Comments on 1772 Church Street Project: Residential Building

Church Street Neighbors and DC Historic Designs, LLC

ANC 2B Zoning Preservation & Development Committee

July 2014

CAS Riegler Project Height Study

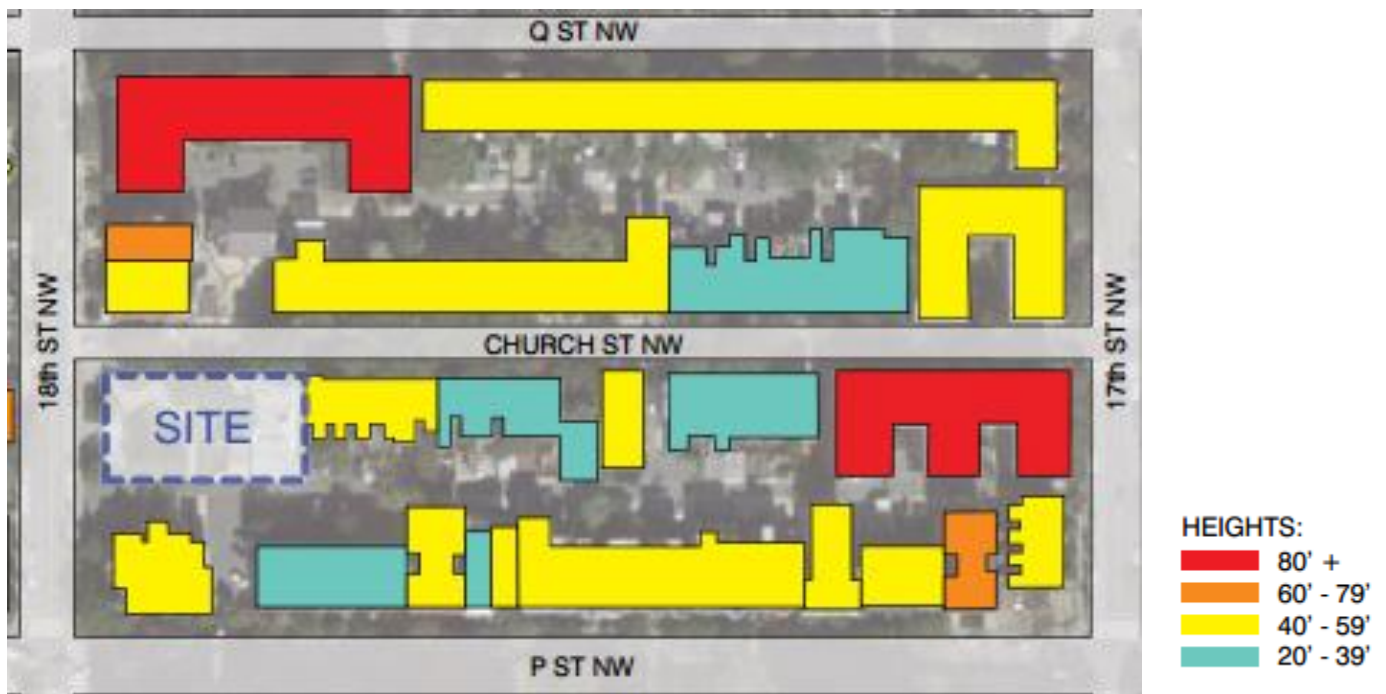
CAS Riegler's height study for the proposed residential building at 1772 Church Street is misleading and cannot be used for justifying both the heights of a new church and a residential building for the same project. The relevant buildings for comparison of a residential building are the immediately adjacent buildings along the interior of the Church Street block, rather than just any of the taller buildings that can be identified throughout the broader neighborhood.

While taller buildings used as comparables in this study may justify the height of the new church, as they are located on the corners of much wider streets, but the buildings cited in the study are inappropriately used as comparables for the residential building located in the interior of the Church Street block between 17th and 18th Street. They exceed the height of the current Parish Hall and the residential buildings on Church Street by as much as 40' and more.

CAS Riegler Project Height Study Sheet A-5.

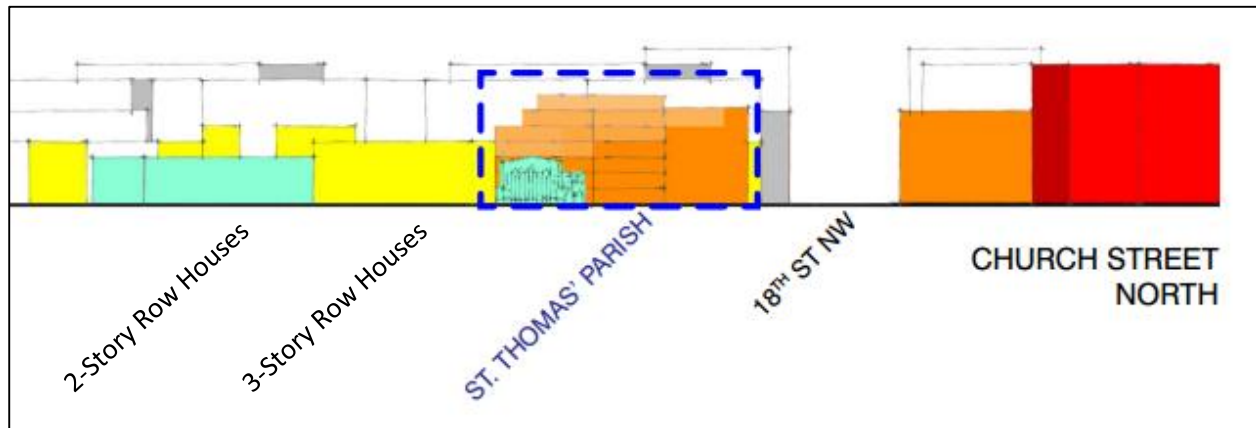
All the 80' + buildings along the north side of the 1700 block of Massachusetts Avenue included in the height study, with the exception of 1785 Massachusetts Avenue, are outside the period of significance for the Dupont Circle Historic District (after 1931). Three of the larger buildings cited on Sheet A-4 (80' +) in the study as context for the large residential building are also outside the period of significance for the Historic District and therefore should not be used as comparables for either the church or the residential building (Numbers 1, 2, and 3 below).

1747 Church Street (#4 below) is depicted out of context with its neighboring buildings and gives the impression of a tall building in the center of the block. It is actually on the same scale as the three-story rowhouses to its immediate west and therefore does not serve as a justification for a taller building.

CAS Riegler Project Height Study. Sheet A-6.

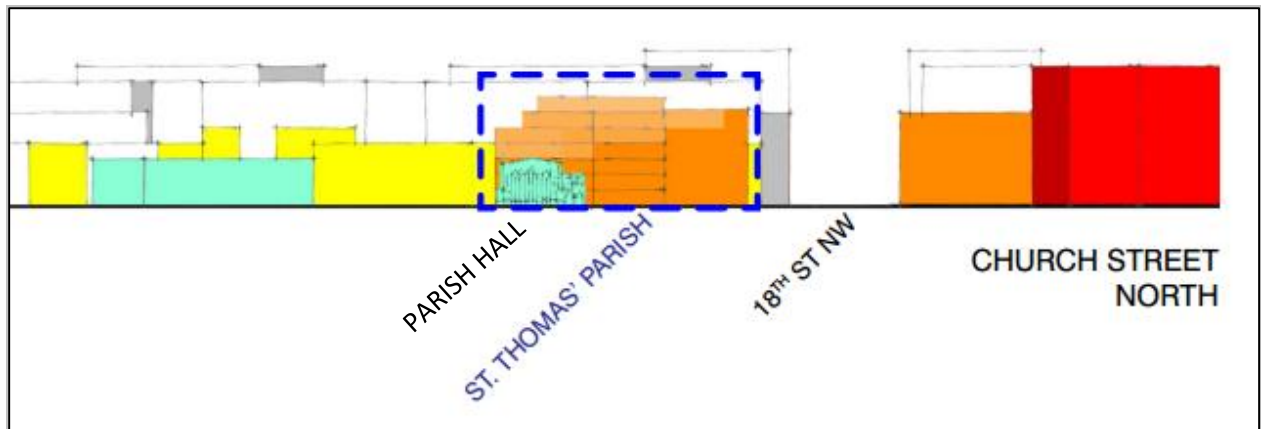
From the example given in CAS Riegler's own height study, the adverse effects of applying these heights to development on Church Street are clear. The proposed residential building towers over the adjacent 3-story row houses (in yellow below) and in particular over the 2-story row houses (in turquoise below).

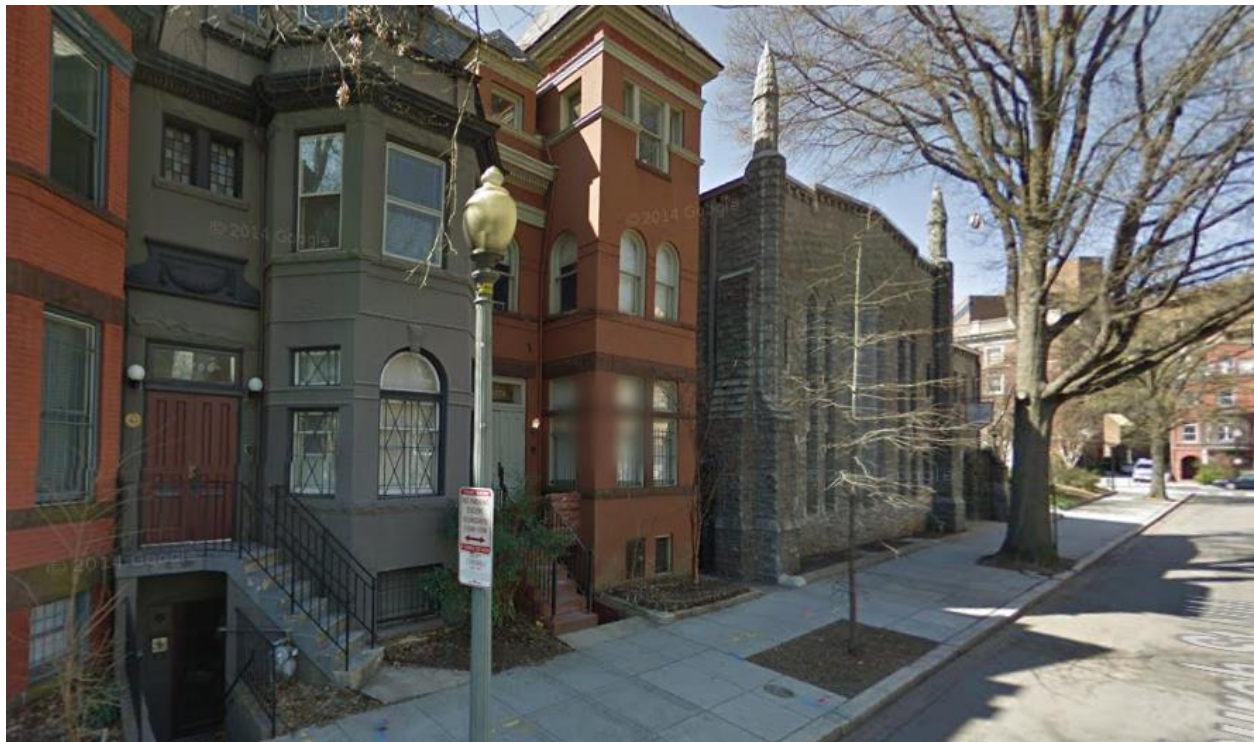
Due to the proposed total height of just under 80 feet (not including any additional necessary mechanical equipment above the penthouse), the residential building will be extremely visible from any perspective,

not only from within the historical context of Church Street itself but from all other view sheds as well. It will loom above any of the other buildings in sight, including the proposed new church itself.
